1 Q. **Re: CBA, Rev. 1, vol. II, Wabush Terminal Station Upgrades, page 2 (p. 428 pdf)**

TP-TN-054

Lab West Industrial Customer Curtailment/Interruptible Assessment

Figure 1 – Labrador West Projected Load Profile for 2019 – Existing System

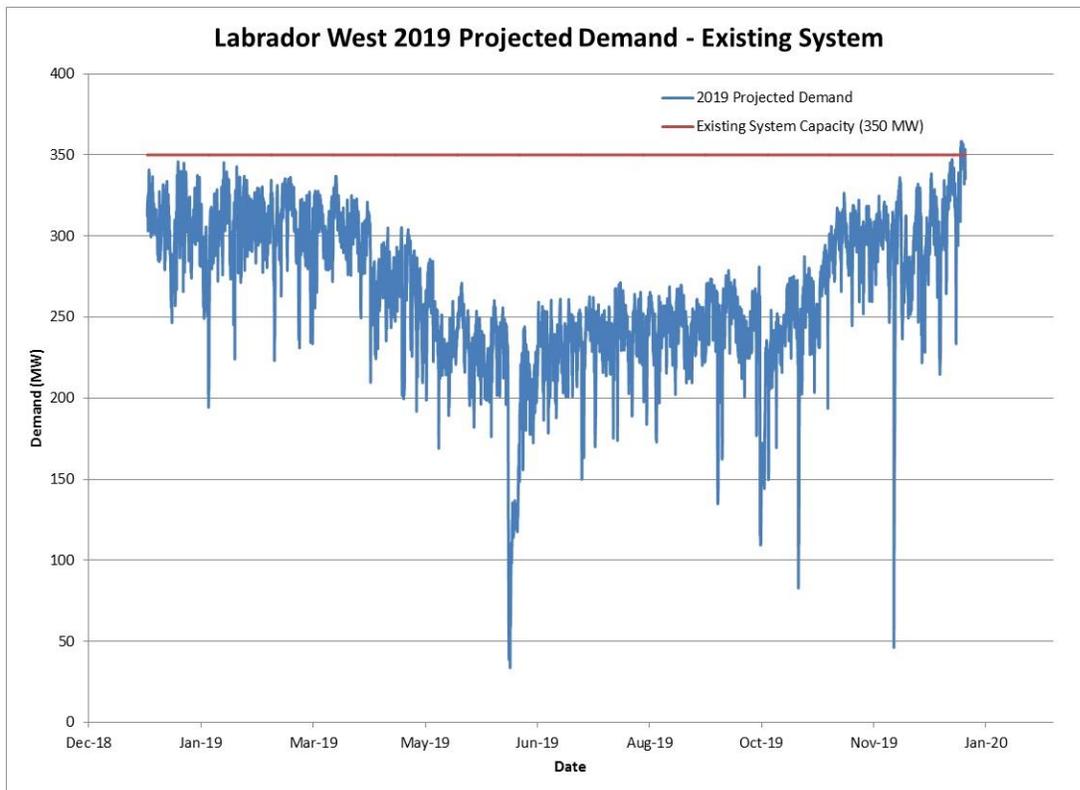
Figure 1 is a plot of the projected Labrador West demand for 2019, which shows that it is during this timeframe that the load is first expected to exceed the existing system capacity of 350 MW. Analysis estimates this to consist of a single interruption with a duration of approximately 24 hours in the month of December.

Figure 2 – Labrador West Projected Load Profile for 2043 – Existing System

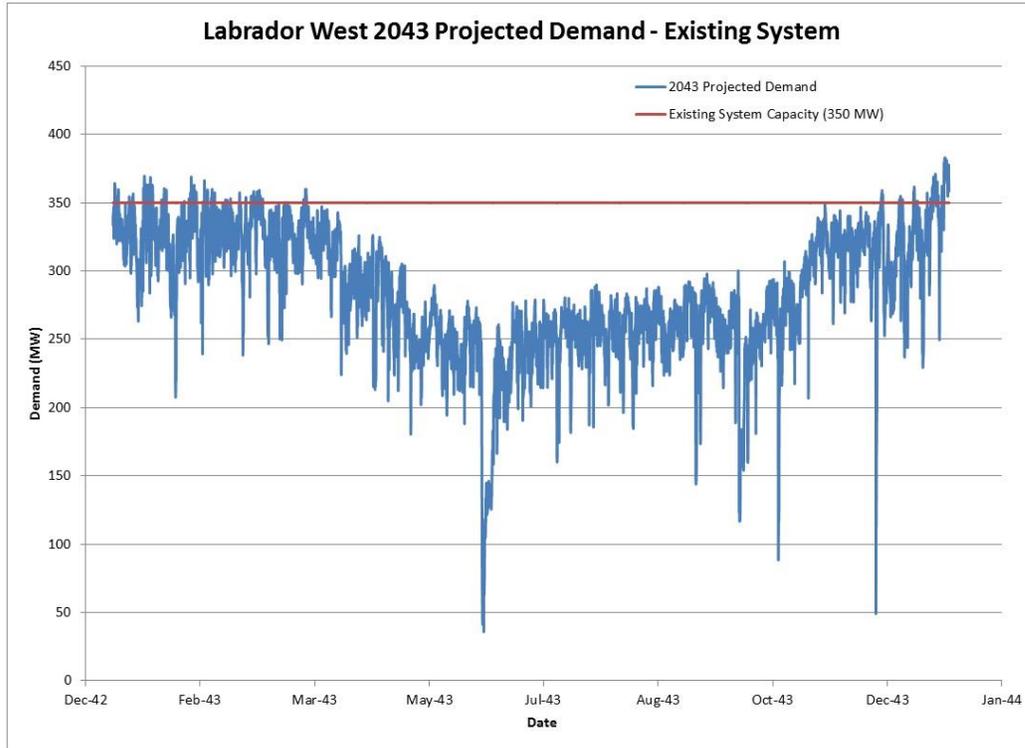
In comparison, Figure 2 is a plot of the projected Labrador West demand for 2043. The plot illustrates that the projected load is expected to exceed system capacity throughout the winter months of January,

February and March, as well as December. Analysis estimates this to consist of approximately fifty interruptions, with a minimum duration of four hours, and a maximum duration of approximately 122 hours.

Figure 3 – Labrador West Projected Load Profile for 2043 – System with SC3

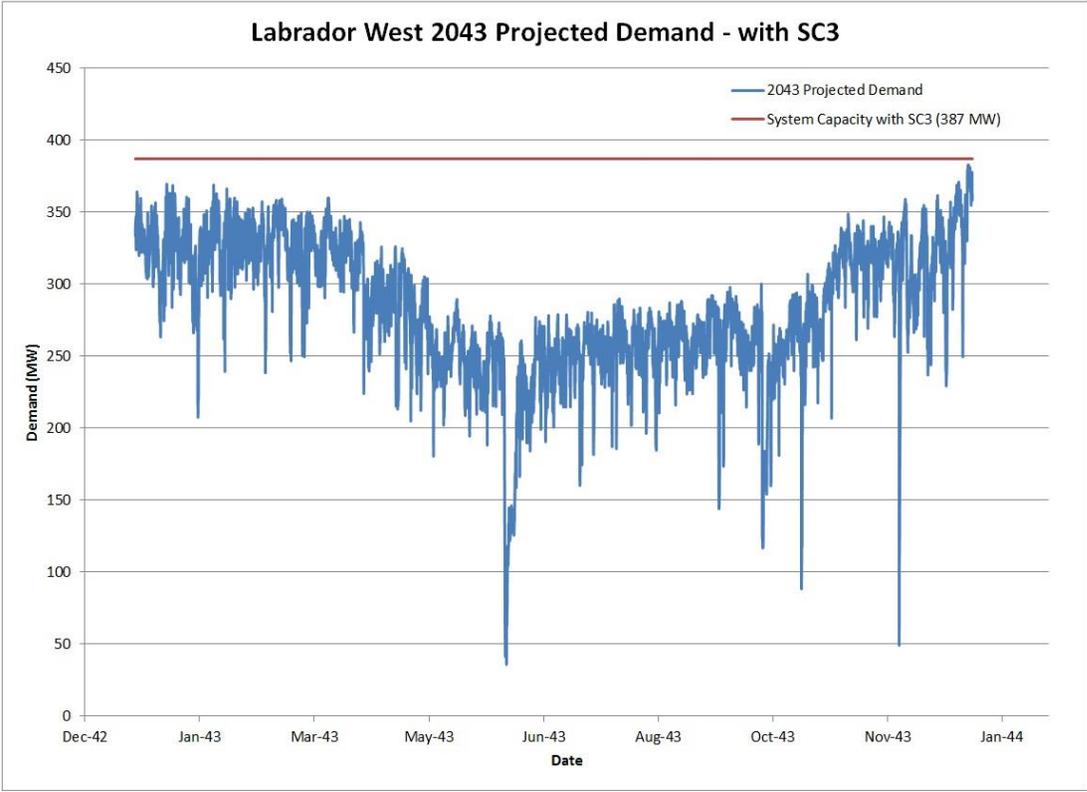
Figure 3 is a plot of the projected Labrador West demand for 2043, in the scenario where WTS synchronous condenser #3 has been commissioned. The plot illustrates that the projected load is not expected to exceed the system capacity of 387 MW in the twenty five year study period.
